RECORD SET

FINAL DEVELOPMENT PLAN
TORIAN PARKING STRUCTURE
WATERPROOFING / RENOVATION - PHASE 2
1855 SKI TIME SQUARE DRIVE
STEAMBOAT SPRINGS, CO

TORIAN PLUM H.O.A.
OCTOBER 20, 2017
100% CONSTRUCTION DOCUMENTS

C2.0

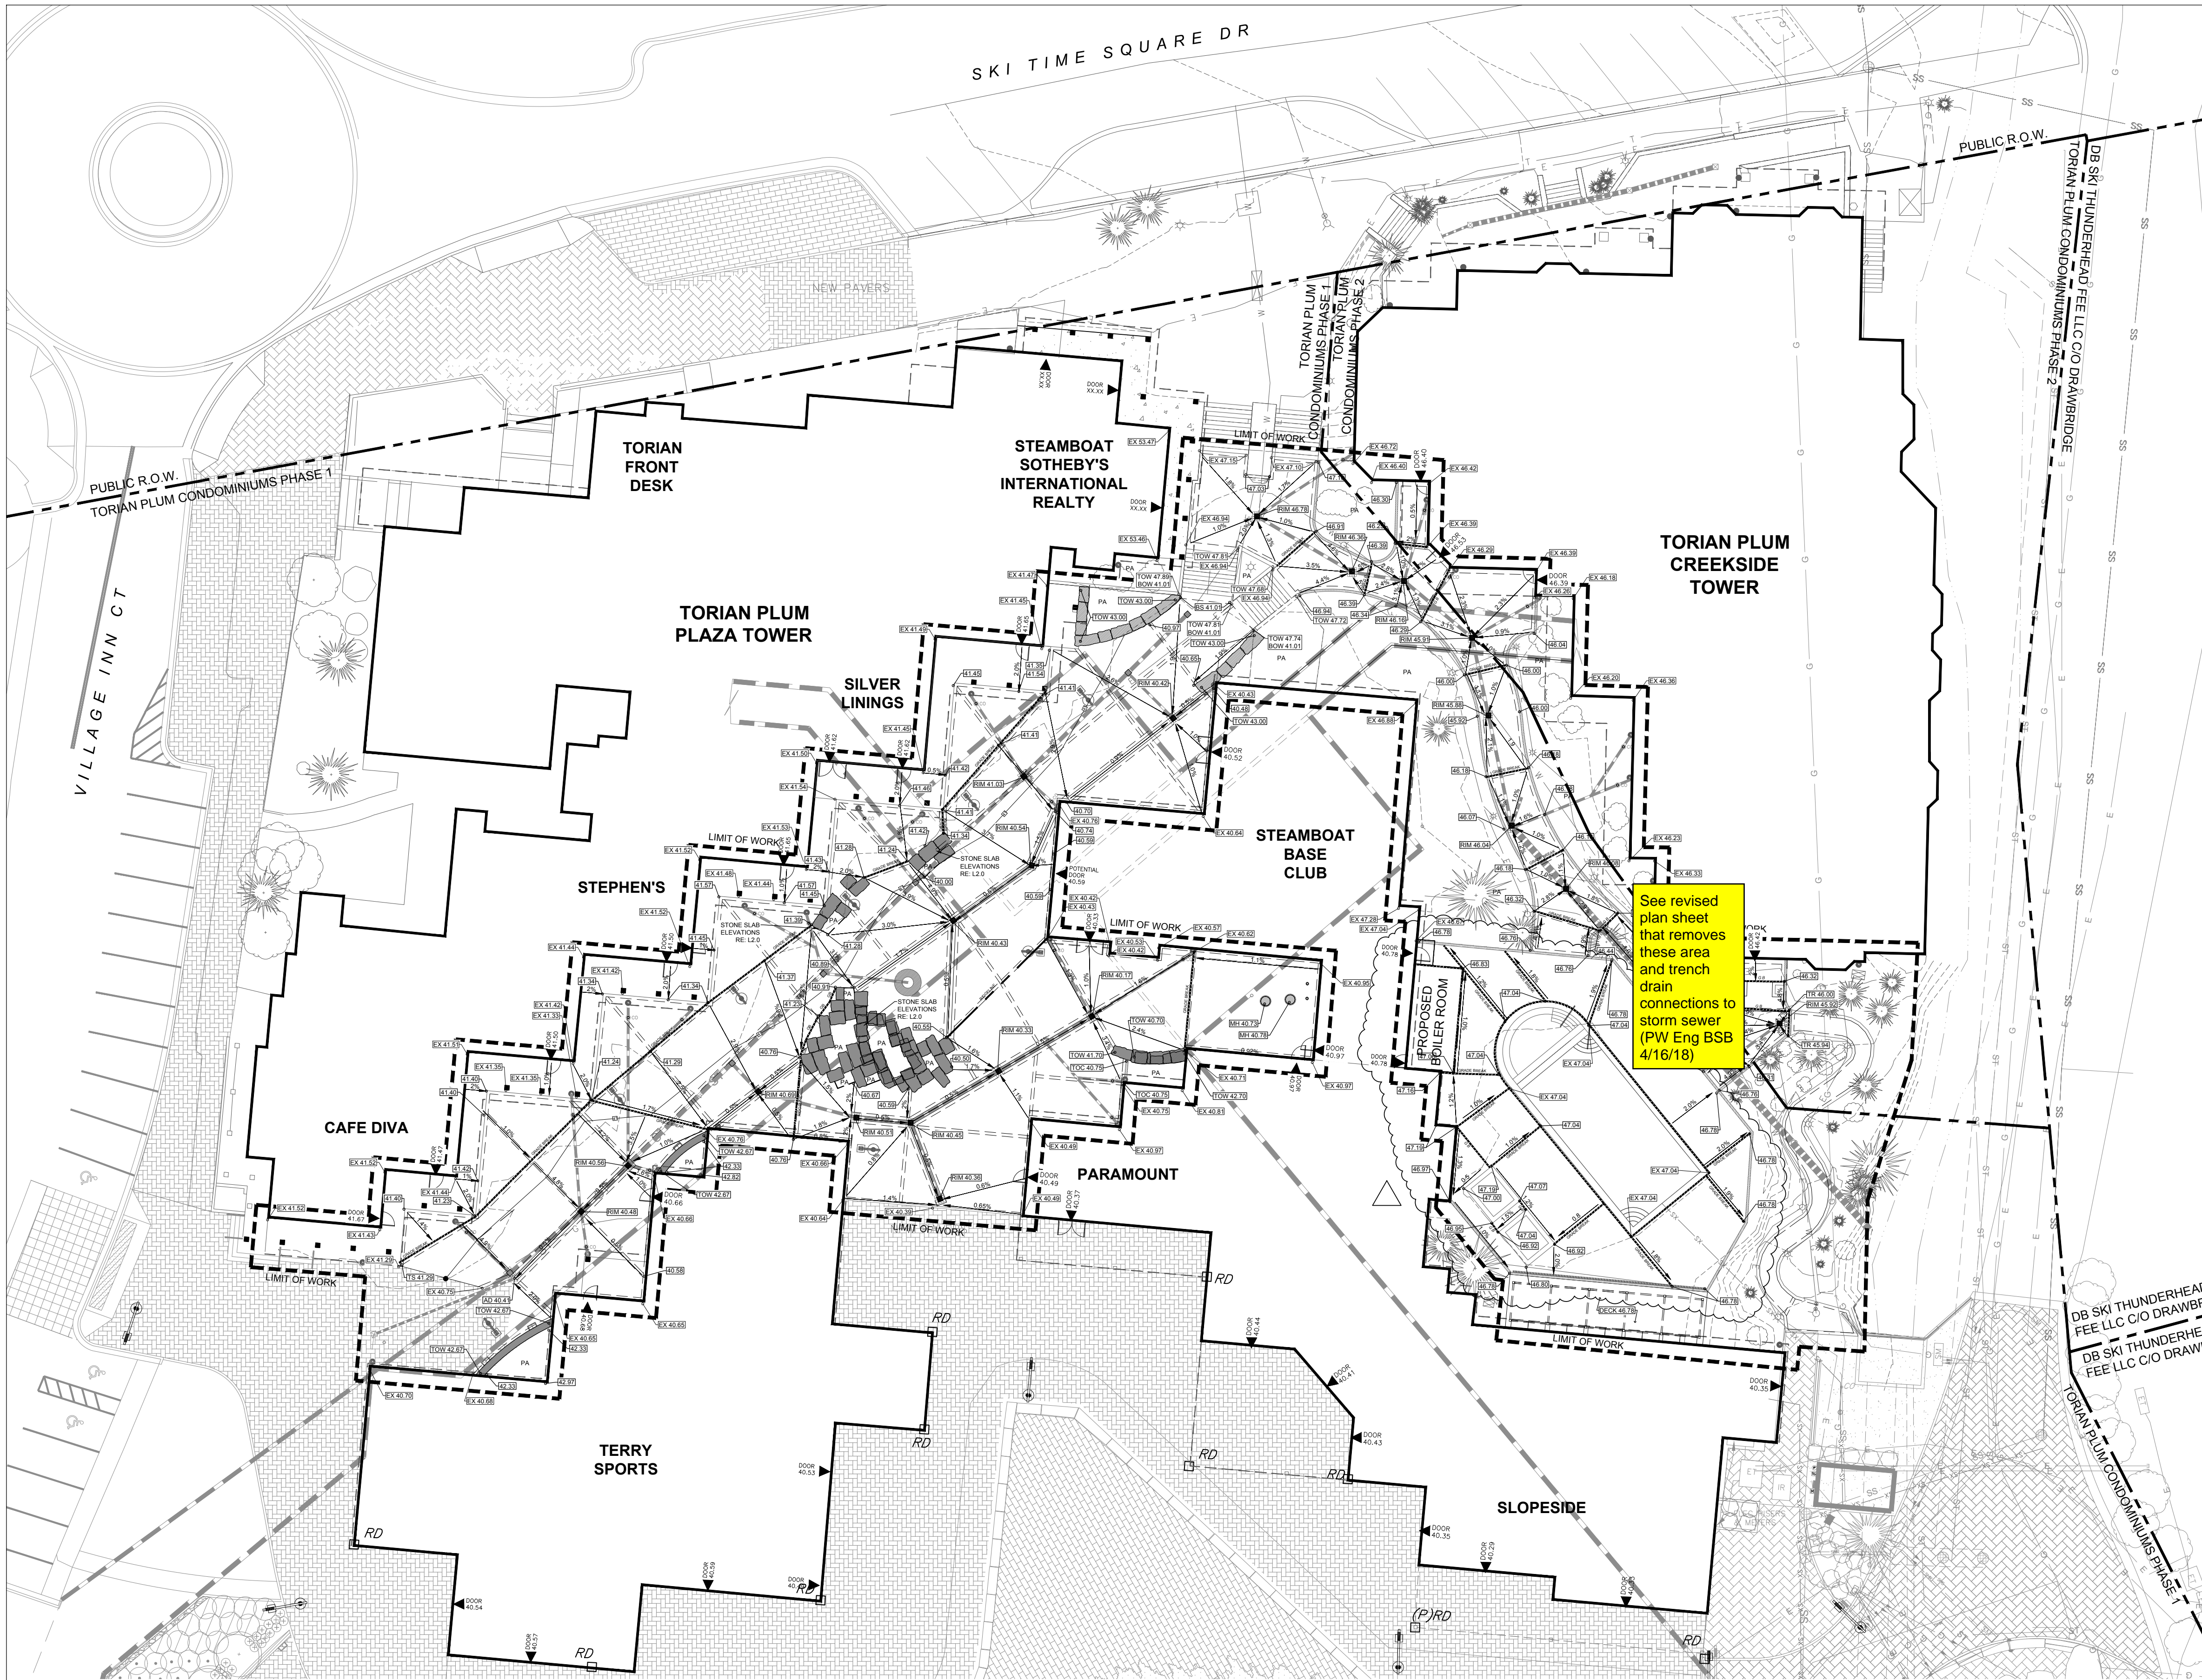
See revised plan sheet that removes these area and trench drain connections to storm sewer (PW Eng BSB 4/16/18)
